Response to a Request for Further Information

**Site C, College Lane, Greenogue, Rathcoole, Co.
Dublin**

RE: RESPONSE TO A REQUEST FOR FURTHER INFORMATION IN RESPECT OF AN APPLICATION FOR A WAREHOUSE DEVELOPMENT AT A SITE KNOWN AS SITE C, COLLEGE LANE, GREENOGUE, RATHCOOLE, CO. DUBLIN

South Dublin County Council Reg. Ref.: SD21A/0200

Figure 2.2: Extract from Proposed Site Plan Proposed as Part of Planning Application Stage (Left) and the Site Plan Now Proposed at RFI Stage (Right)

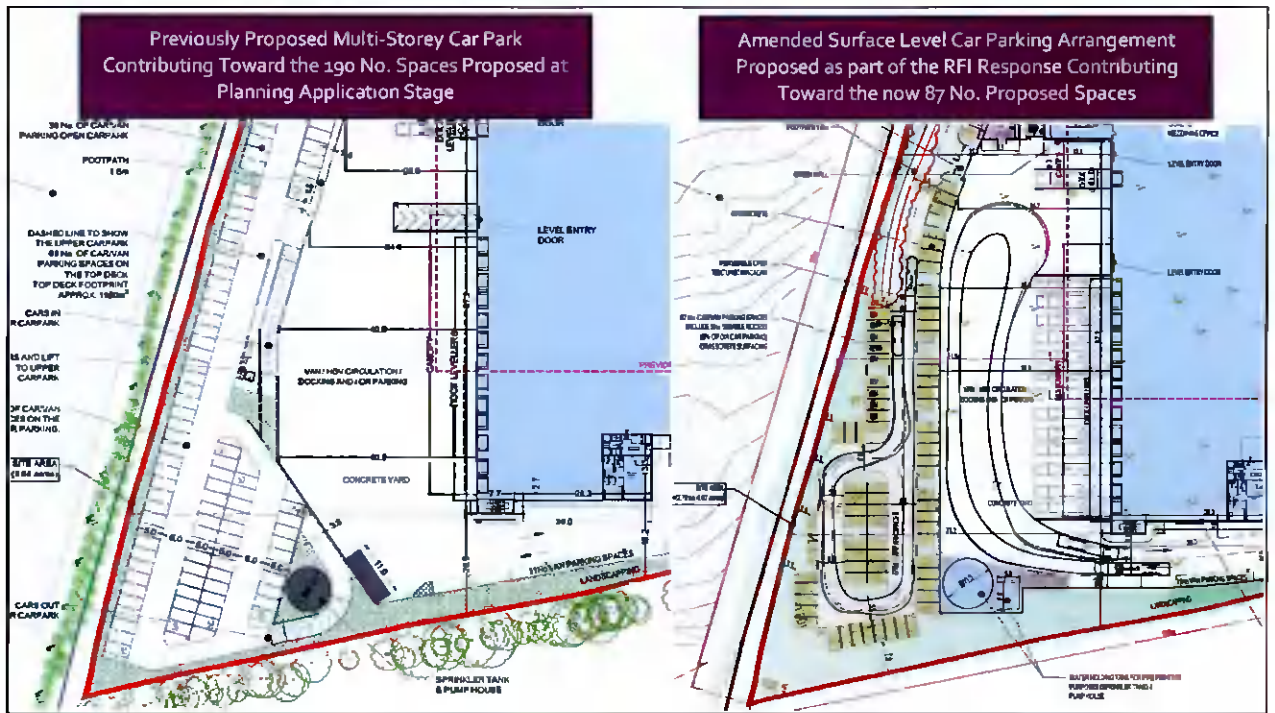
(3) The proposed increase in floor area results in the proposal to provide a multi-storey car park at this location. The Planning Authority has serious concerns regarding the proposal for a multi-storey car park on this site and in the vicinity of this site. Policy directs people intensive enterprise and employment into lands zoned for town centres and village centres and in location to good public transport. This is not the case at this location. A development requiring a multi-storey car park should be directed towards towns and villages. The granting of a multi-storey car park would be undesirable at this location and should be omitted. A revised design, site layout plan, and supporting reports shall be submitted to address all the points made.

A reduced provision of car parking is now proposed and the multi-storey element has been removed from the proposal in place of a surface-level car parking arrangement. This has also allowed for an increase in the provision of SuDS measures and landscaping on the site. Some 87 No. spaces are now proposed, reduced from the 190 No. car parking spaces proposed at planning application stage (and also reduced from the 119 No. already permitted at the site). An extract from the Site Plan proposed at Planning Application stage and the Site Plan now proposed at *Request for Further Information* stage has been included below:

Figure 2-3: Location of Proposed Bicycle Parking on Site Plan

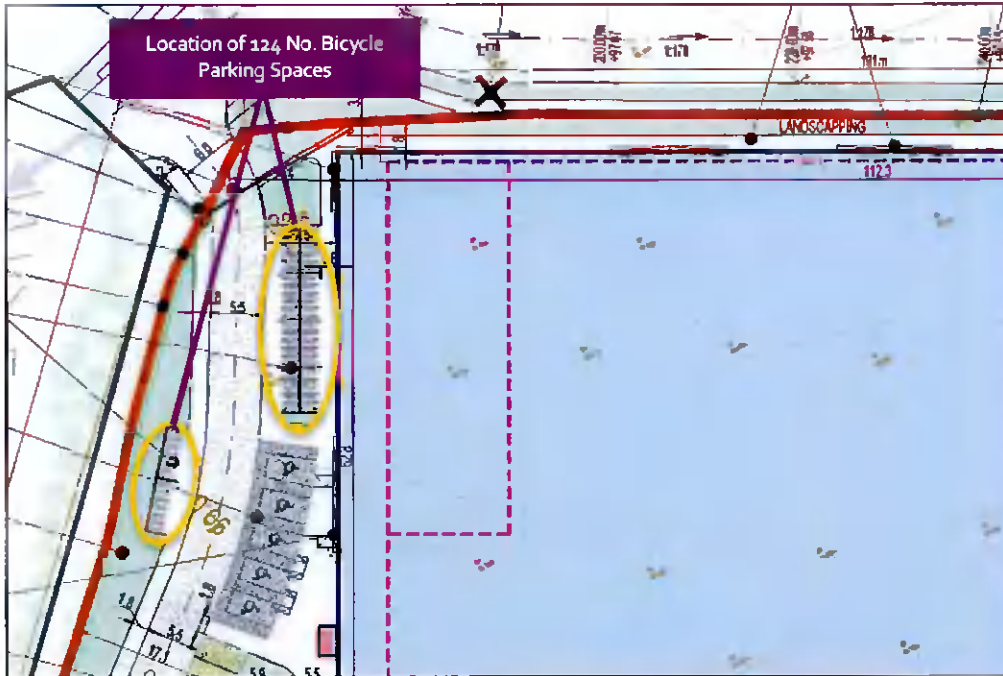
(4) 72 permitted bicycle spaces are proposed. Under the County Development Plan one space is required per 200sq.m of additional floor space. In this instance this is 70 additional spaces. The applicant is requested to provide a total of 142 covered bicycle spaces. A revised layout plan shall outline the location of these 142 spaces.'

As a result of the revisions to the proposed floor area, some 124 No. bicycle parking spaces are now proposed as part of the *Request for Further Information Response* in accordance with the *South Dublin County Council Development Plan 2016-2022* where one space is required per 200sq m of floor space. Given 24,704 sq m of gross floor space (not including staff facilities and plant room areas) is now proposed at *Request for Further Information* stage some 124 No. bicycle parking spaces are required. The 124 No. proposed meets this requirement. An extract from the proposed Site Plan has been included in the Figure below showing the location of the 124 No. proposed bicycle spaces.

Figure 2.6: Swept Path Analysis from the Southwestern Portion of the Lands

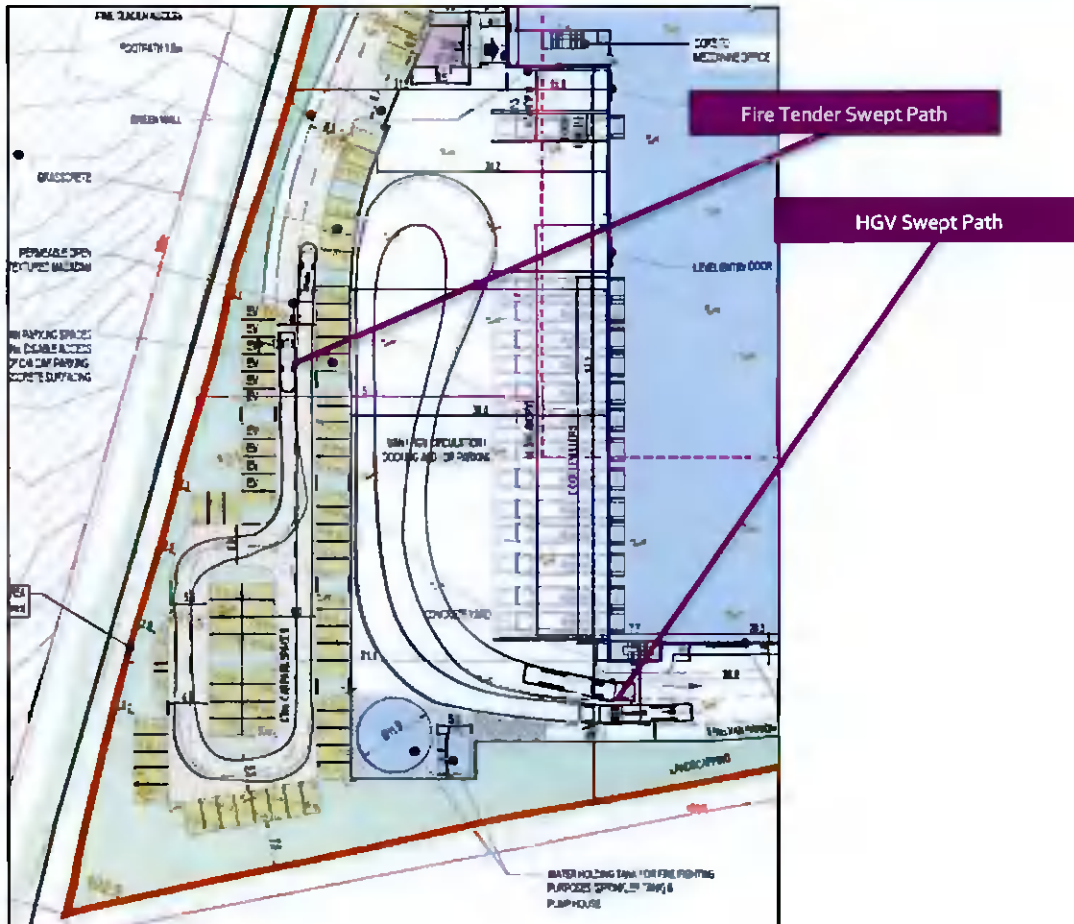
(5) A swept path analysis for fire tenders and HGVs showing access to all required locations of the site shall be submitted and agreed by the Planning Authority. (Taking note of the requirement to provide Green Infrastructure throughout the site).

An extract of the Site Plan drawing, prepared by Kavanagh Burke Consulting Engineers, has been included below for the southwestern and southeastern portion of the site below:

Figure 2.8: Electric Vehicle Charging Facilities

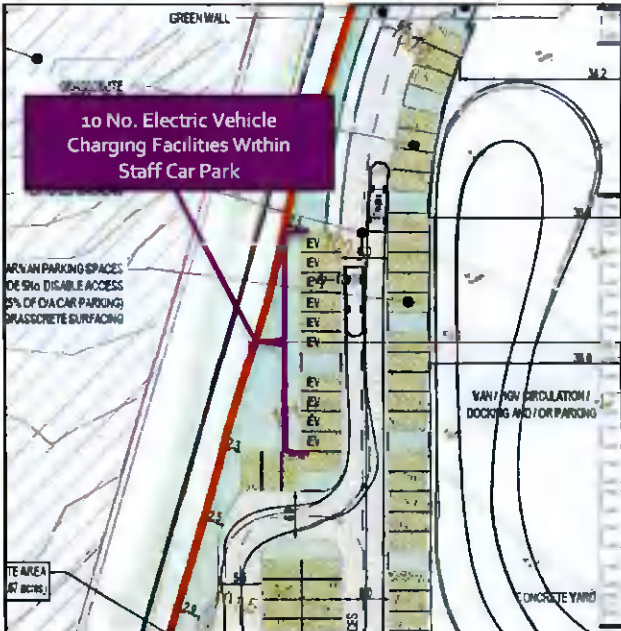
(6) A revised layout showing the Electric vehicle parking provision and facilities for charging electric vehicles within the proposed staff car parks.'

The location of the 10 No. EV Car Parking Spaces has been shown below on the Site Plan drawing (Drawing No. D1658 D2) prepared by Kavanagh Burke Consulting Engineers:

Figure 2.9: Location of Proposed Green Roof

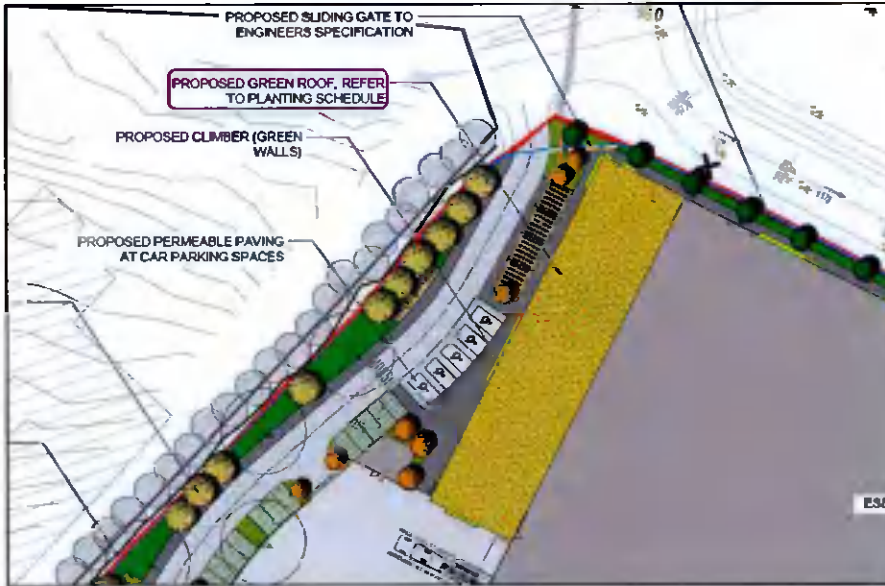
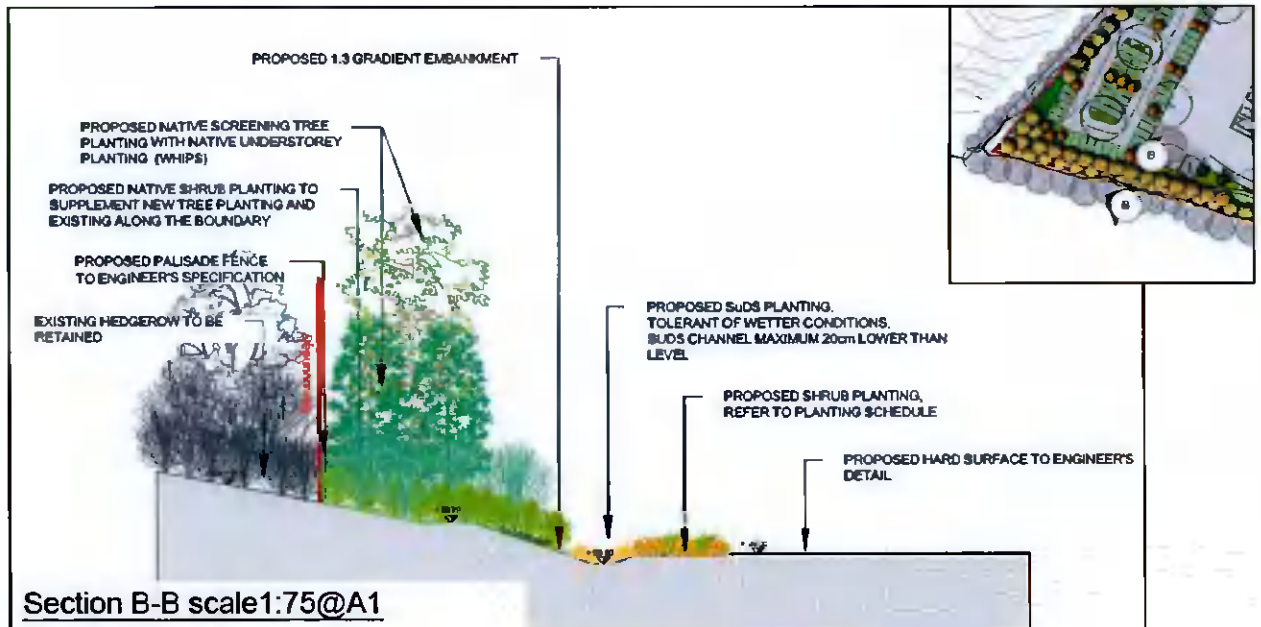
(a) A green roof/part green roof (over the office building)

One such redesign element is the proposed green roof provided over the office element of the proposed warehouse. An extract from the Landscape Masterplan (Drawing No. CER-JBAI-XX-XX-DR-L-0002) prepared by JBA Consulting has been included below showing the location of the proposed green roof:

Figure 2.11: Initial and Revised Landscape Masterplan

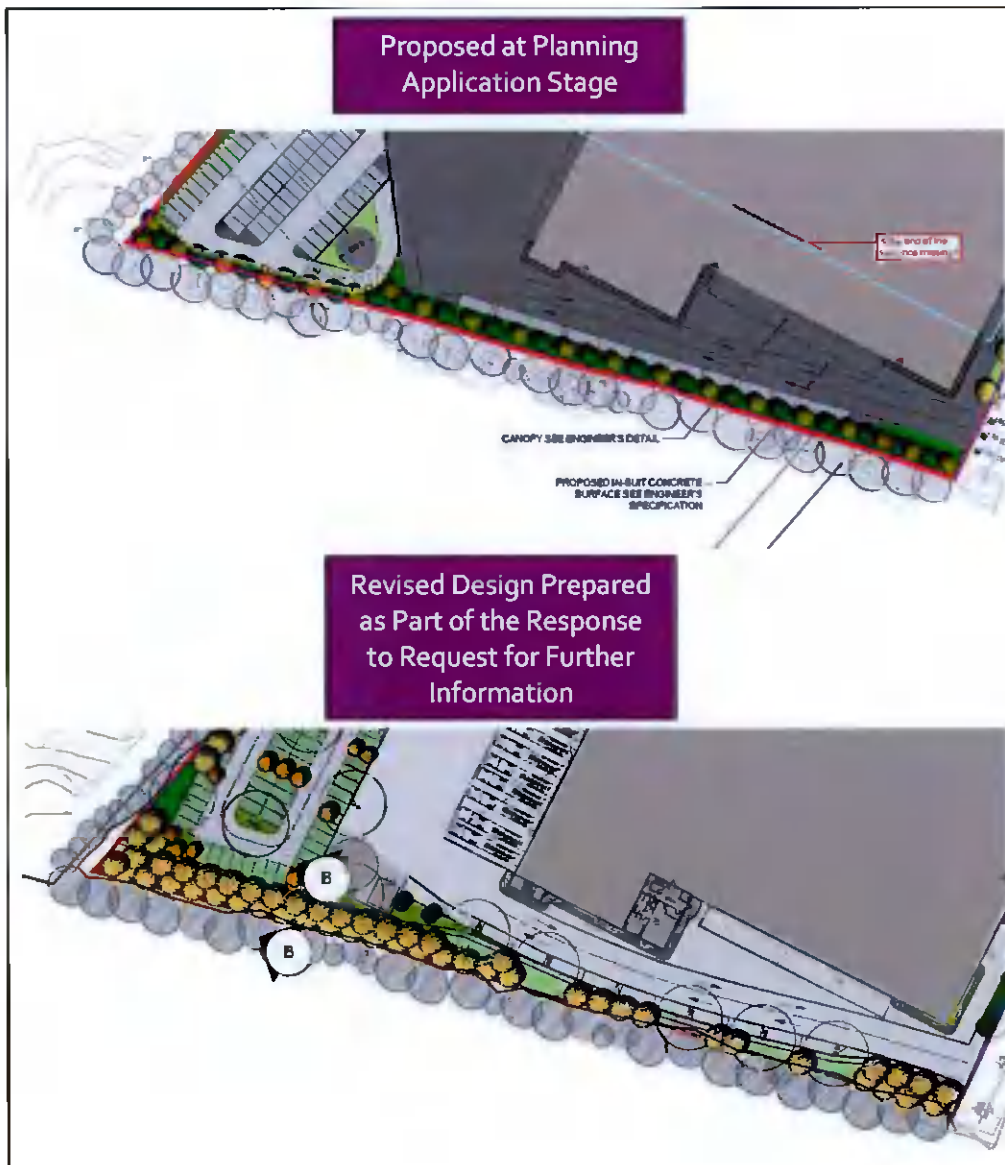
(c) Increased planting, berms and greened-buffer zones around the perimeter of the site, especially the southern boundary.

The southern boundary has received particular attention by the Design Team in this *Response to Further Information Request*. Increased planting has been provided along the southern boundary with proposed native screening tree planting and proposed native shrub planting. An extract from the Landscape Masterplan proposed at Planning Application stage and the revised design prepared as part of this *Response to Request for Further Information* have been included below.

Figure 2.13: Initial and Revised Landscape Masterplan

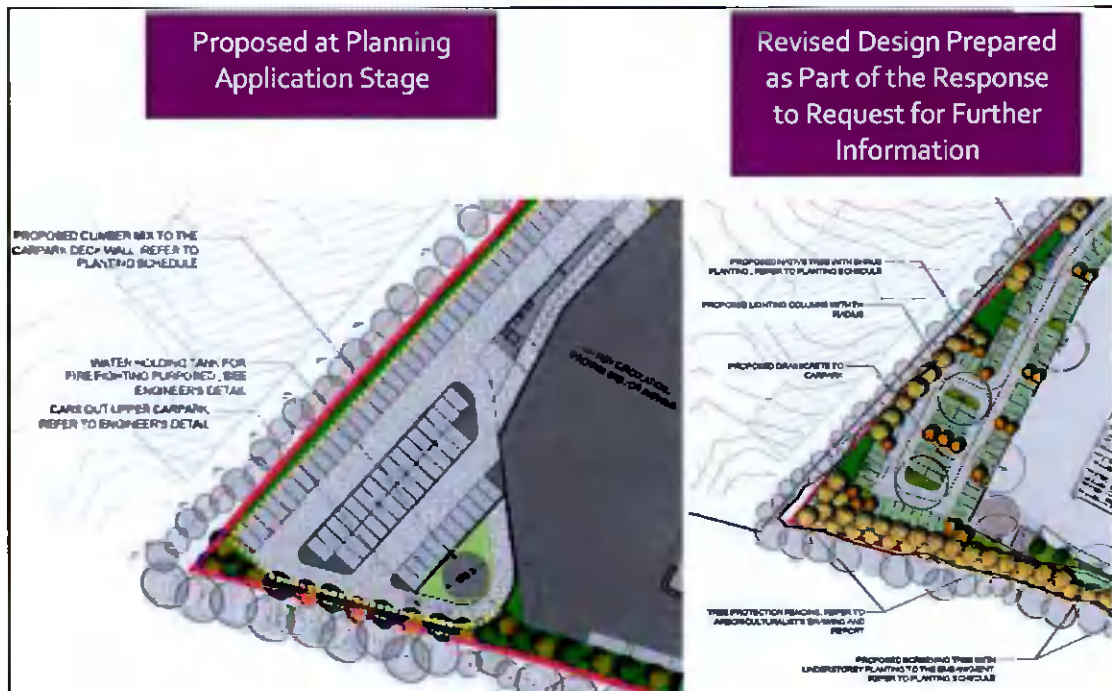
(b) Street trees along the eastern boundary access road and within the car park shall also be a minimum 20-25cmg at planting.

Along the eastern boundary access road, street trees have been provided for as shown in the Landscape Masterplan (Drawing No. CER-JBAI-XX-XX-DR-L-0002) prepared by JBA Consulting.

With regard to within the car parking area, increased amounts of planting have been provided for as shown in the Figure below, ensuring that the warehouse scheme is not legible as a hard surfaced environment but instead is legible as a high quality designed warehouse scheme.
